The United Illuminating Company
157 Church Street
P.O. Box 1564
New Haven, CT 06506-0901
203.499.2000

Re: Docket No. 317 – The United Illuminating Company Application for a Certificate of Environmental Compatibility and Public Need for the Construction, Maintenance, and Operation of a Proposed 115-kV/13.8-kV Electric Substation and Associated Facilities Located at 307 Wildflower Lane, Trumbull Connecticut

Enclosed are an original and 20 copies of The United Illuminating Company's responses to the Wildflower Coalition and the Town of Trumbull's interrogatories (Set 2) and the pre-filed testimony of Richard J. Reed.

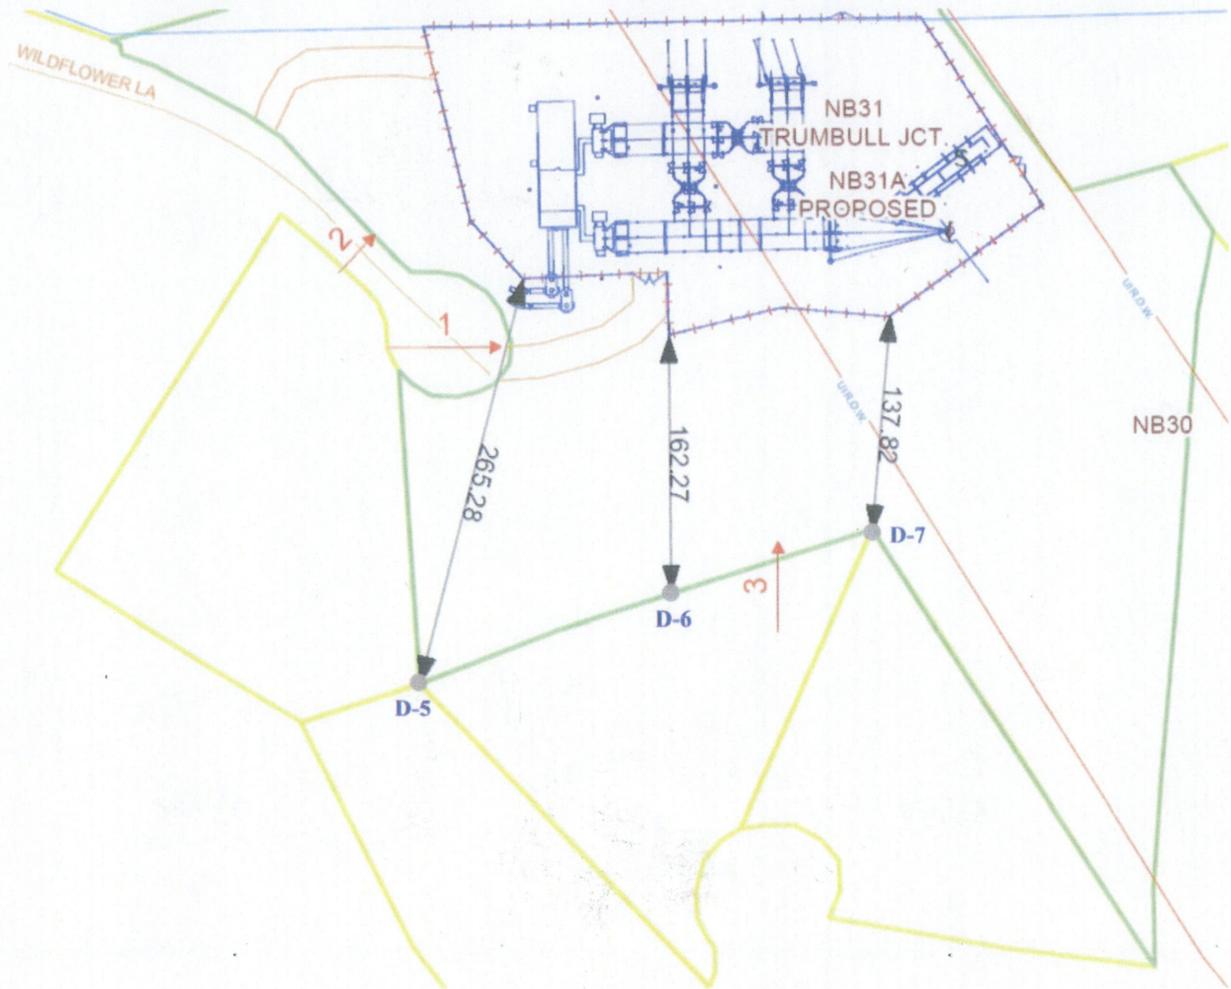
Q-WCP-13: Is there any reason why that access cannot be used for the substation?

A-WCP-13: Assuming that the State of Connecticut easement allows UI to improve the access road and use it as the permanent primary entrance to the proposed substation, it can be used as a means of substation access.

The primary design constraint for the substation access is the turning radius of UI's mobile substation transformer. In an emergency condition, the mobile transformer must be able to pull in next to the transformers under the 115 kV bus. The distances between the fenceline and substation structures must be sufficient to accommodate the turning radius of the mobile substation trailer.

One potential design for substation access would be to arrive and exit the substation from Nichols Ave. In order to accommodate the turning radius of the mobile transformer the fenceline along the northern and southern boundaries must be expanded approximately 20' each.

A sketch of this design with the turning radii is included below:

This design would also require UI to negotiate an easement with the State of Connecticut to pass from UI's property line at the easterly fence boundary, back to the existing access easement.

Trumbull Substation Proposed Site
3 - 7 Wildflower La, Trumbull CT

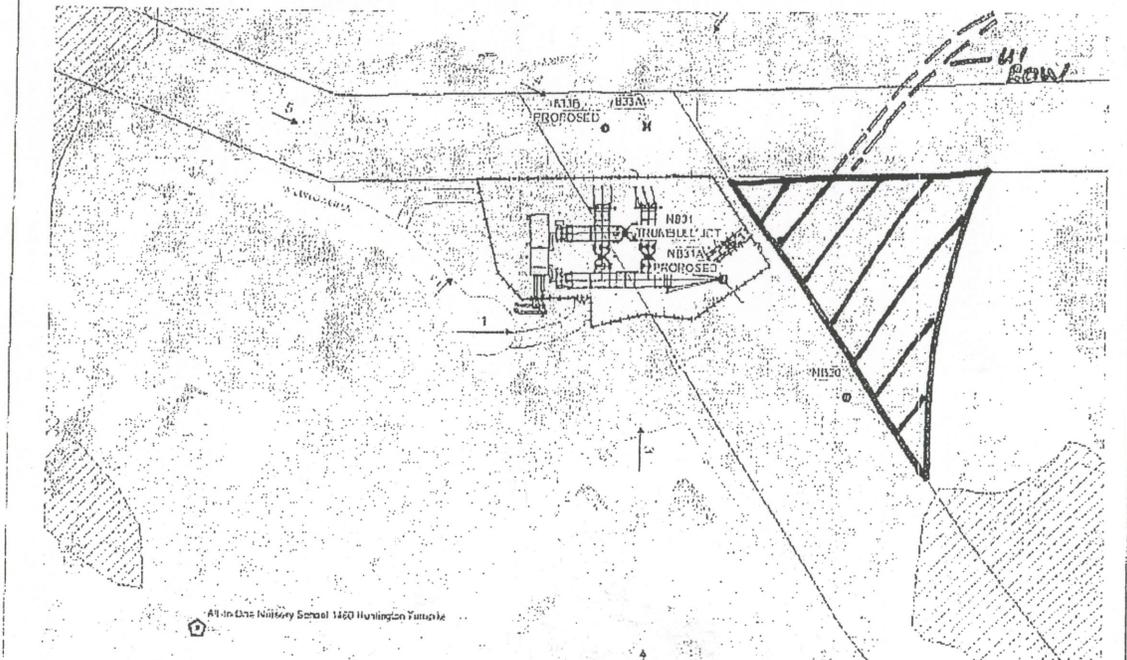
Q-WCP-15: Refer to Application Exhibit L.

- a. Identify who owns the parcel(s) of property that comprise the triangular section of property at the junction of and to the east of the UI right of way and the south of the CL&P right of way.
- b. Confirm the aggregate size of all of the size of the parcels comprising the triangle.
- c. Identify whether UI ever considered this site as a possible location for the substation, particularly since it already had access rights to the property.
- d. Confirm whether UI ever did any studies, test or analysis on this site
- e. As this site is at the same junction of the UI and CL&P transmission lines, doesn't it offer the claimed technical benefits as the Wildflower Lane site?

- a. The State of Connecticut owns the parcels immediately to the east of UI right of way.
- b. Based on a drawing received from the Wildflower Coalition Petitioners, the size of the referenced triangle is 1.45 acres. This drawing is included below:
- c. Based on previous inquiries by UI, the State of Connecticut has indicated that it is not willing to give up any land that might be required for future highway improvements. UI again made a request of the Department of Transportation Property Management Division, asking the agency to respond to this question at this specific location. A response has not been received.
- d. No.
- e. In general, the location of the parcel would allow for the transmission benefit associated with the Wildflower Lane site.
